**AUTHORIZING A CHANGE ORDER IN THE DECREASED AMOUNT OF \$25,988.88 TO THE \$1,665,669.83 CONSTRUCTION CONTRACT WITH SHORTY, INC. DBA CHARLIE & COMPANY FOR THE PHIL HARDBERGER PARK PHASE II PROJECT, AN AUTHORIZED 2009 TAX NOTES FUNDED PROJECT.**

CHANGE ORDER 01

Project: PHIL HARDBERGER PARK PHASE II  
40-00134

SCALE:	DRAWN:	SKETCH
NTS	JE, CB	SK-L1

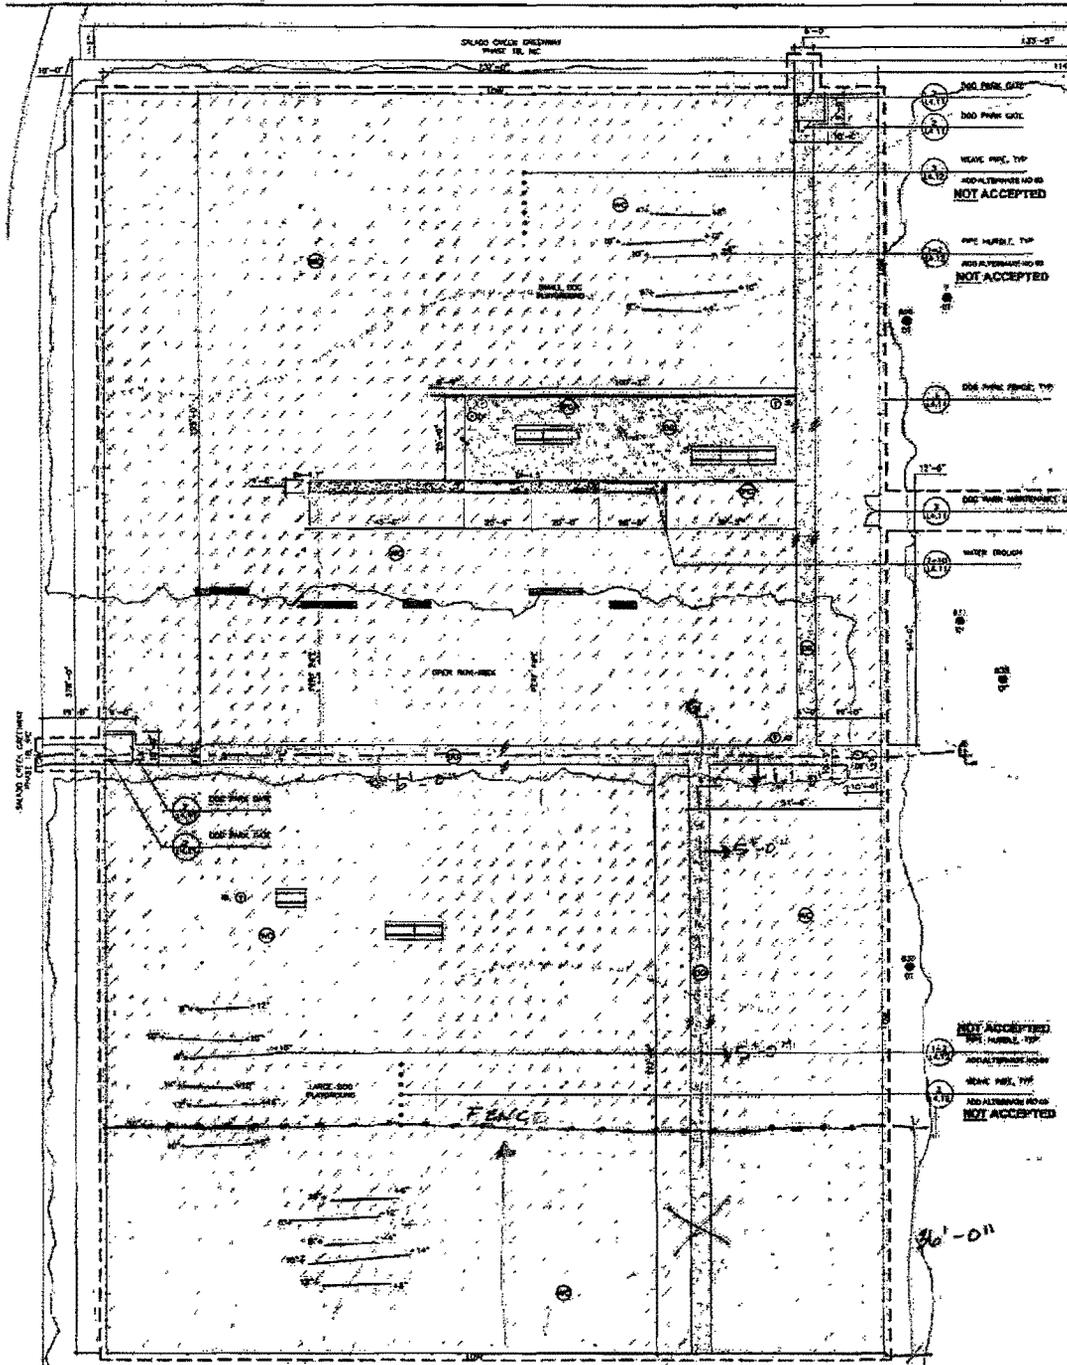
01 SK-L1 SALADO CREEK DOG PARK LAYOUT REVISIONS  
Revise Salado Creek Dog Park Layout as indicated in drawing including reduction in fencing length, clearing scope, decomposed granite and steel edging.

- NOTES:
- NO CLEARING BEYOND FENCE LINE
  - REVISE CLEARING ZONE 'C' FOR "OPEN RUN AREA" TO CLEARING ZONE E
  - SHIFT NORTHEAST FENCELINE AS SHOWN
  - SHIFT CENTERLINE OF DG PATHS AS SHOWN
  - 12' MAINTENANCE ACCESS TO BE STAKED AND APPROVED BY LA / OWNER PRIOR TO CLEARING

Reduce Clearing by 8352 S.F.	< 2,700.00 >
Reduce D.G. Walk by 216 S.F.	< 479.00 >
Reduce Steel Edging by S 72 L.F.	< 634.00 >
Reduce Fence by 72 L.F.	< 710.00 >
	<u>&lt; 4,523.00 &gt;</u>

SCALE:	DRAWN:	SKETCH
NTS	CB	SK-L2

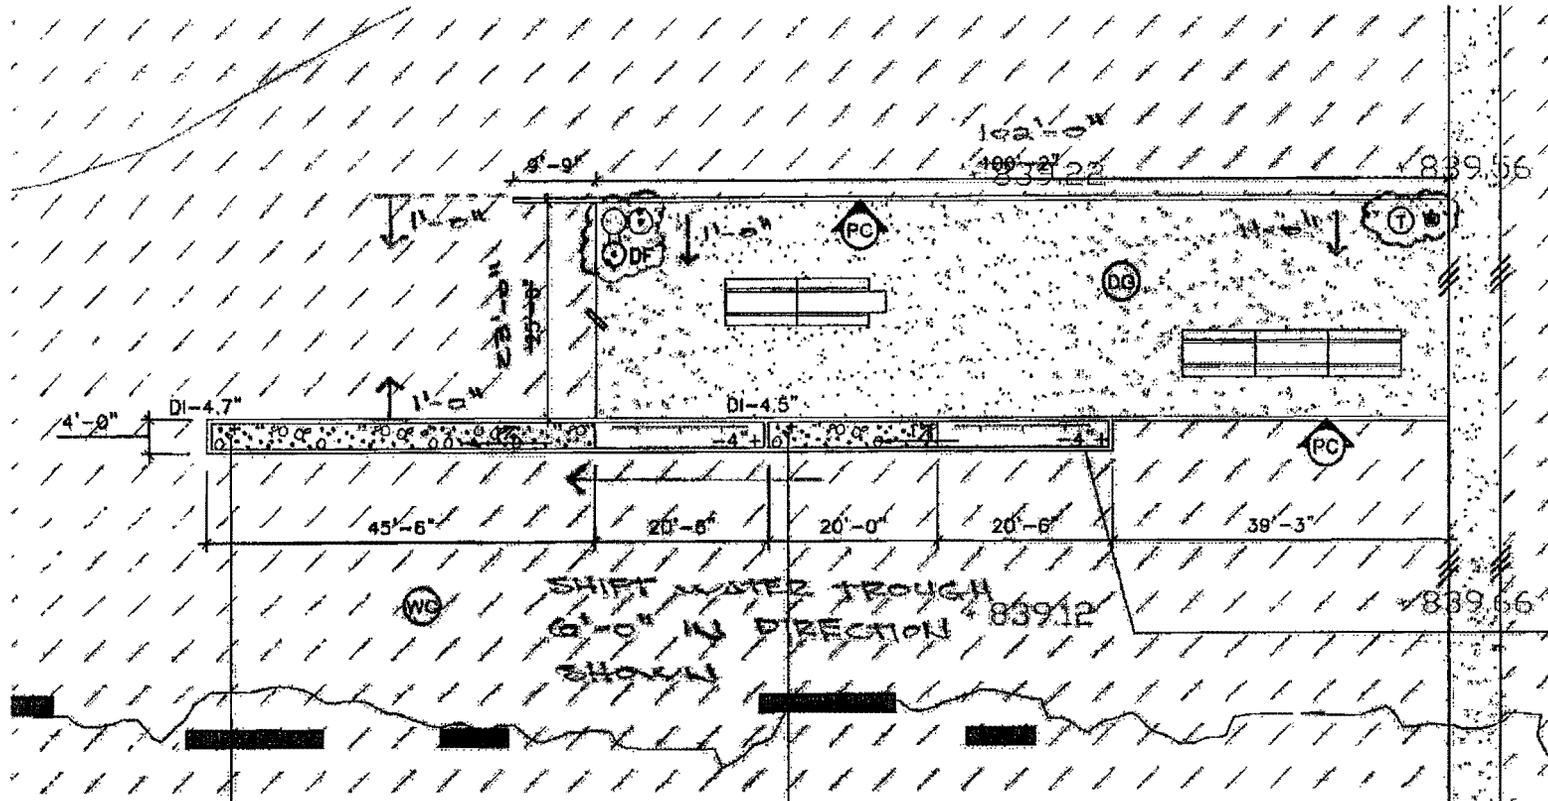
- 01 SK-L2 SALADO CREEK DOG PARK LAYOUT REVISIONS  
Revise Salado Creek Dog Park Picnic Area Layout as indicated on the drawing, to include: water trough, flush picnic curb, drinking fountain, trash receptacle shifts; and, add/deduct SF of decomposed granite paving material.
- 02 SOUTH FIELD PICNIC AREA / MAINTENANCE YARD / DOG RUN CONCRETE WALKWAY  
Reduce overall width of walkway from 10'-0" to 8'-0", TYP. Shift the south edge of pavement 2'-0" to meet the revised walkway width dimension. Refer to sheets L3.10 "South Field Recreation Layout & Materials Plan and L3.30 "South Field Maintenance Yard and Dog Run Layout & Materials Plan."
- 03 STEEL EDGING AT GEOLOGY LOOP TRAIL  
Maintain an allowance for 1600 LF of steel edging at the proposed Geology Loop Trail. Refer to sheets L2.00 "East Parcel Site Plan and Site Preparation" and L4.30 "Details-Trails."

<b>Item 01</b>	SK-L2 Salado Creek Dog Park Layout Revisions Deduct D.G. 154 S.F.	< 341.88>
<b>Item 02</b>	South Field Picnic Area, Maintenance Yard, Dog Run Concrete Walkway Reduce Walkway by 2'	< 3,069.00>
<b>Item 02</b>	Steel Edging at Geology Trail Reduce Steel Edging by 7170 L.F. Add D.G. Haunch to both sides of trail edge	<52,183.00>

SCALE: 1" = 1'-0"	DRAWN: JET/L	SKETCH
SALADO CREEK PLAYGROUND PATH IN RPZ - SECTION		SK-L3C

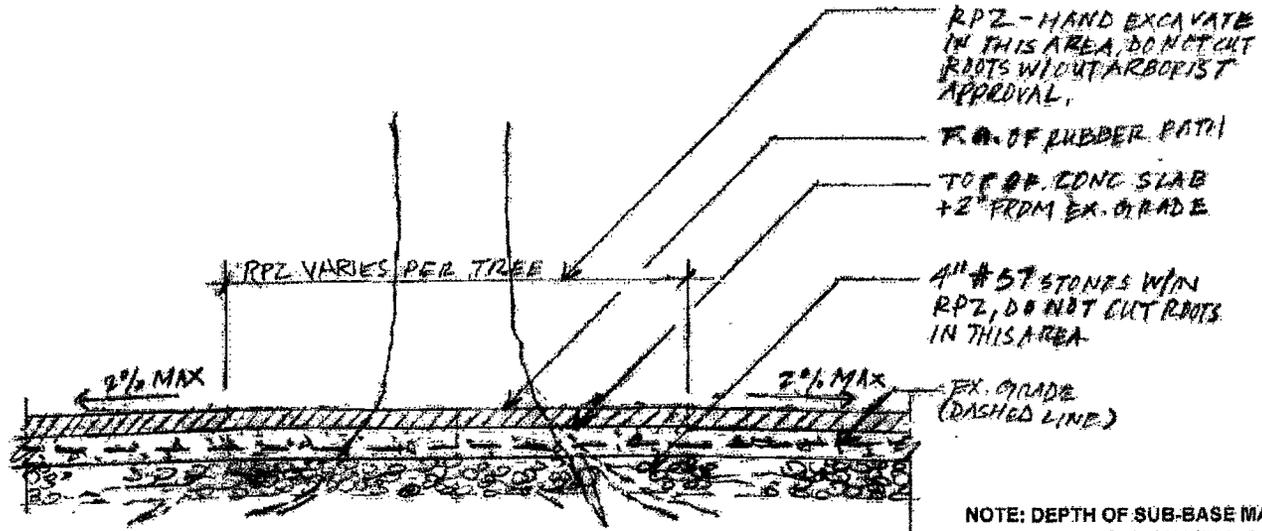
- ITEM: DESCRIPTION:
- 01 SK-L3A SALADO CREEK PLAYGROUND LAYOUT PLAN  
Revise Salado Creek Playground Layout as indicated on the drawing, to include: play pads & paths, drinking fountain location & bench layout.
  - 02 SK-L3B SALADO CREEK PLAYGROUND MATERIALS & DRAINAGE PLAN  
Revise Salado Creek Playground Materials as indicated on the drawing.

NOTE: DEPTH OF SUB-BASE MAY VARY DEPENDING ON FIELD CONDITIONS & TREE ROOT LOCATIONS

**Item 01** Revise Salado Creek Playground layout  
Increase playground area including survey, clearing and  
wood chips, add 40 l.f. fence, arborist

SCALE: NTS	DRAWN: SS	SKETCH
DOG TROUGH SECTION		SK-L4A

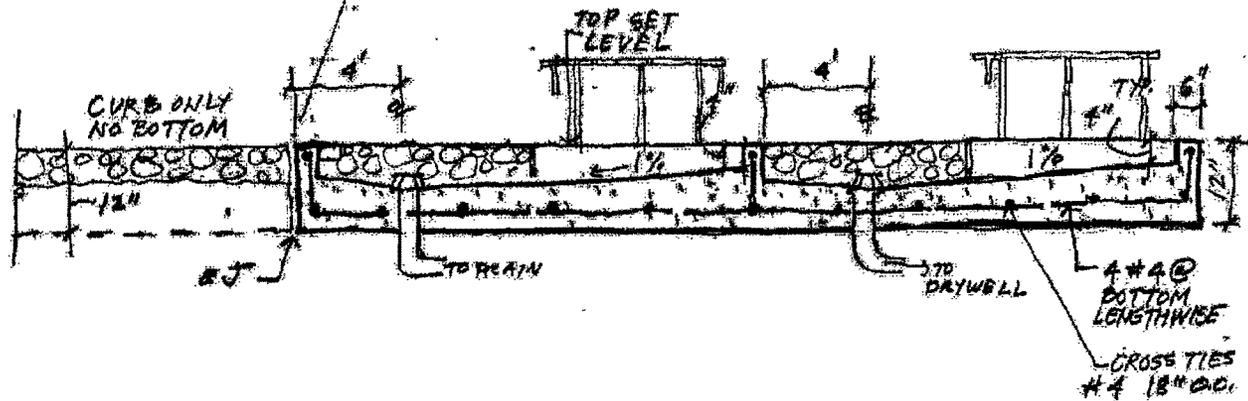
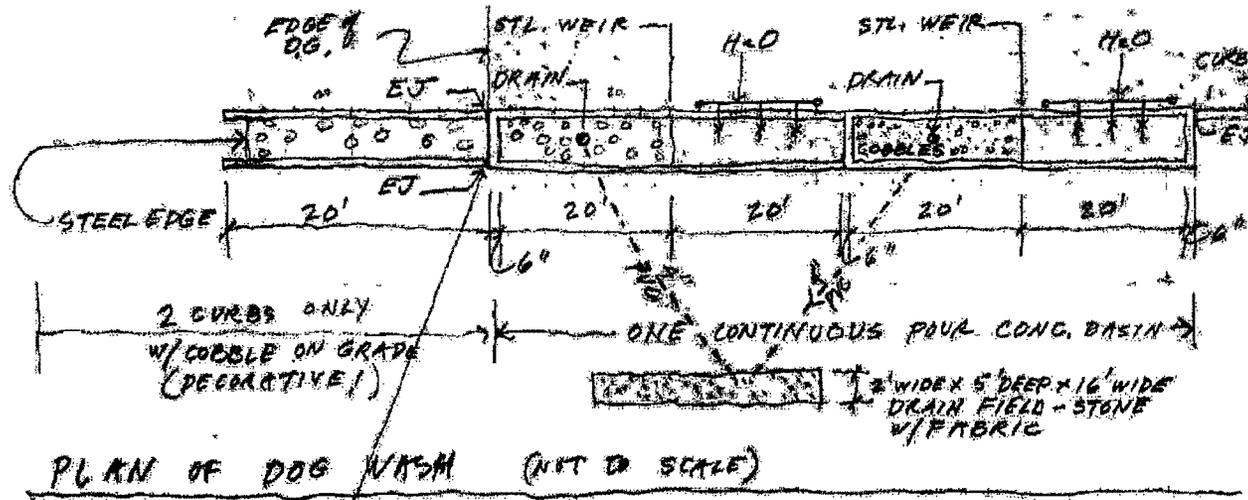
- 01 SK-L1 SALADO CREEK DOG PARK - DOG TROUGH REVISIONS  
 Revise Dog Trough Layout, materials and plumbing as indicated in drawing.
- 02 CONSTRUCTION ACCESS TO DOG PARK AND SALADO CREEK PLAYGROUND  
 Construction access clearing at south edge of dog park, on future Greenway alignment, from Blanco Road to approximately 75' from Greenway. At this point, access to weave through Dog Park between trees as required towards playground. Access route should be planned to minimize tree clearing. Provide tree protection for trees adjacent to route. Height pruning if required to be approved by LA and Owner. Construction access to be 4" wood chip.
- 03 MAINTENANCE YARD  
 Construct maintenance yard with 6" flex base instead of #57 stone. Flexible base to be Type A, Grade 2 compacted to 95% max. dry density in compliance w/ COSA Item 200.

**Item 01 SK-L1 SALADO CREEK DOG PARK - DOG TROUGH REVISIONS**  
Revise Dog Trough Layout, materials and plumbing as indicated in drawing.

**\$ No Change**
